DATE: December 5, 2016
FROM: Michelle Klose, Director of Utility Operations *MK*
ITEM: Change Order Request No. 1 for Wachter Ave Master Lift Station Project

Change Order Number: **1**

Project Description: **Wachter Ave Master Lift Station Project Improvements**

Date of Issuance: 11/28/16	Effective Date: 11/28/16
Owner: City of Bismarck, North Dakota	Owner's Contract No.: SU 16-63
Contractor: Northern Plains Contracting, Inc.	Contractor's Project No.: 16-500
Engineer: Apex Engineering Group	Engineer's Project No.: 10.118.0014
Project: Wachter Avenue Master Lift Station Improvements	Contract Name: General Construction

16-0293 WACHTER LIFT STATION HELICAL PILE RECAP
 DESIGN CAPACTIY 40 KIPS
 ULTIMATE CAPACITY 80 KIPS

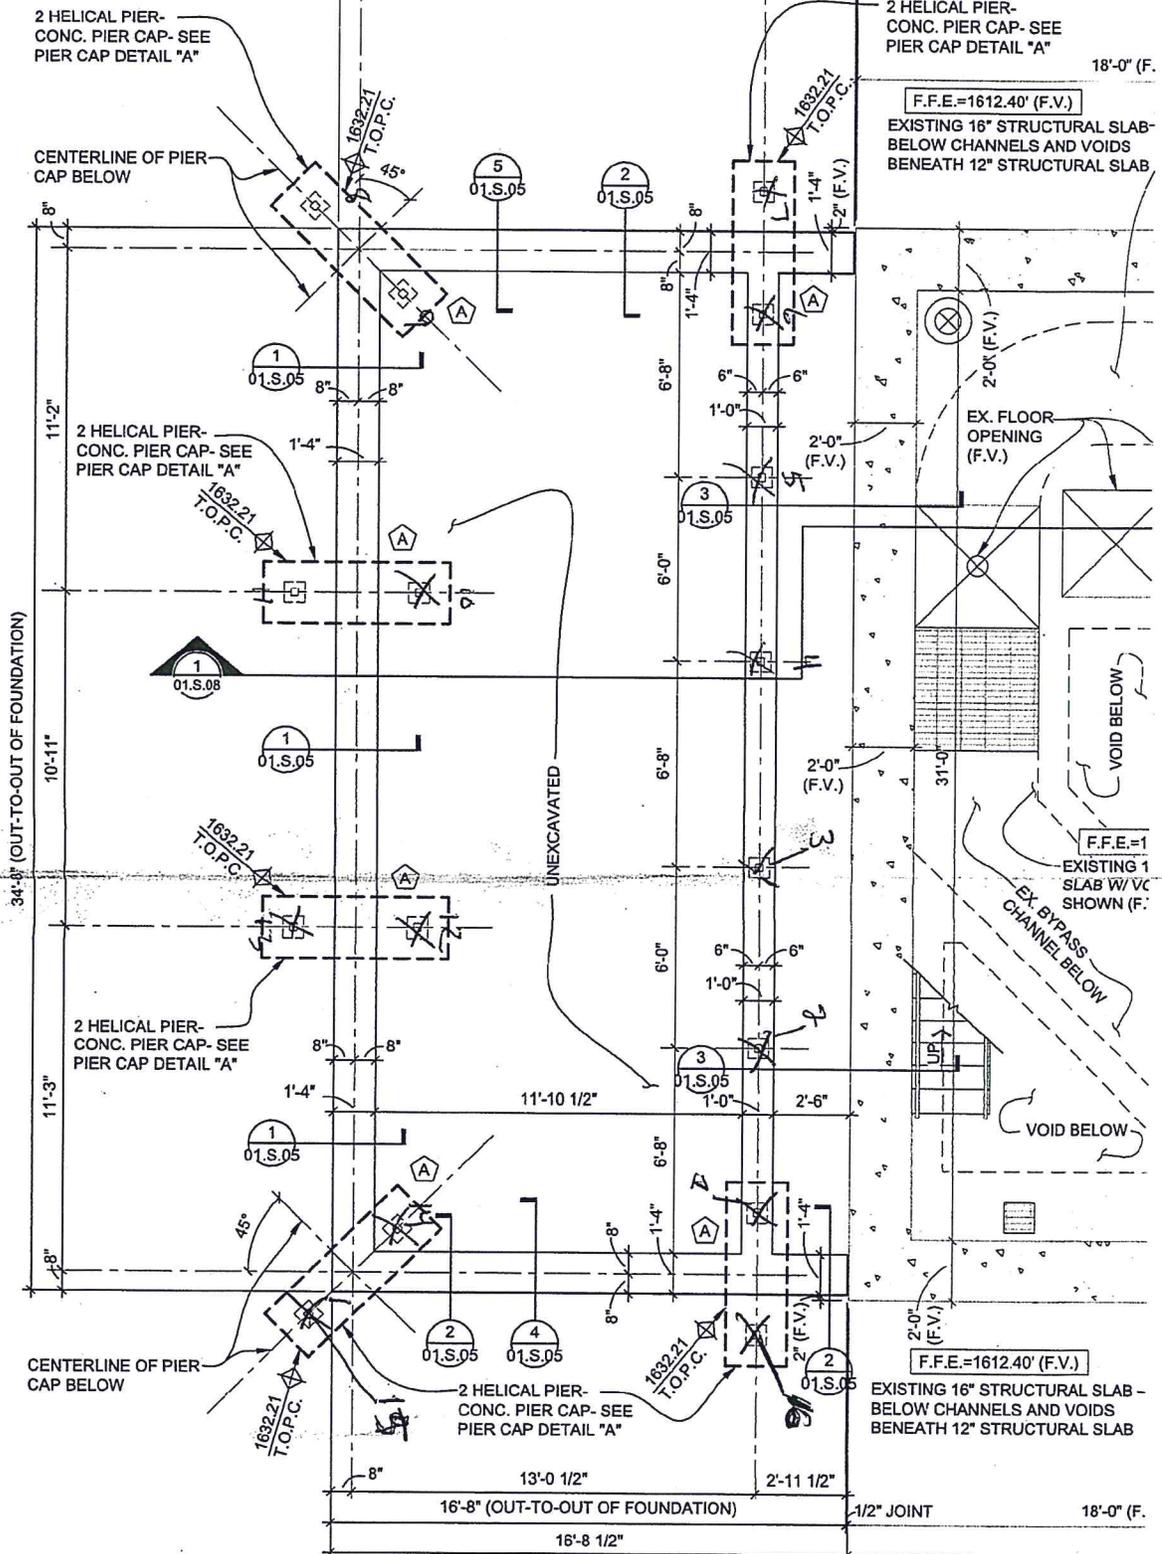
RFC 1 Helical Pier Installation Depth: The new building addition is supported by helical piers. This type of pier is screwed into the soil until a design torque is reached. In the bid phase the contractors designed and bid the helical piers based on soil borings provided in the contract documents. During construction the actual required installation depth was much greater than expected. It is believed that the increased installation depth is due to soil conditions that were materially different from those reasonably anticipated at the time of bid.

Project: Wachter Ave Master Lift Station Improvements
Date: 10/10/2016
CO Description: Helical Pile Installation Adjustment

Apex Response: Approved in the amount of \$16,145 as shown below (MAB 11/10/16).

Estimated 10' Pier Lengths (5 lengths x 16 piers)	80		
Reasonable variability (+/- 10%)	8		
Contractors Responsibility	88		
Installed 10' Pier Lengths	155		
Contractors Responsibility	-88		
Owner's Responsibility	67		
67 additional 10' pier lengths, \$225 per extension		\$15,075	
Contractor Profit & Overhead (5%)		\$754	
Subtotal		\$15,829	
Bond & Insurance (2%)		\$317	
Total Cost		\$16,145
